# Supplementary Planning Committee

### Wednesday 13 January 2016 at 7.00 pm

# **Supplementary Information Planning Committee on 13 January, 2016**

### 4. Planning Committee Map

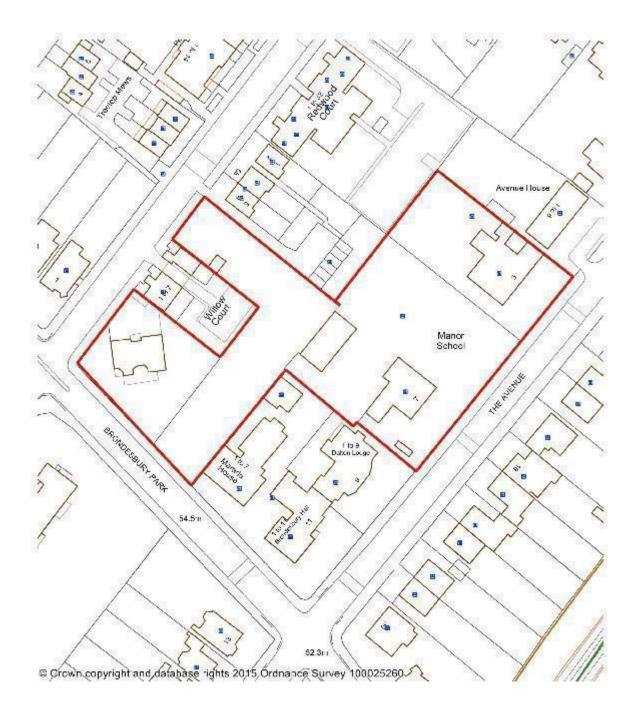
The Planning Committee Map on page 118 is in error, with the red line omitting No. 3 The Avenue. This has not resulted in any procedural error in respect of consultation and the application has been assessed in terms of its impact on the correct neighbour 1-6 Avenue House, however this has been erroneously referred to as 3 The Avenue (or 3TA) in the report (paras 43 and 47), and reference to that should be read as 1-6 Avenue House. A revised map is shown below:
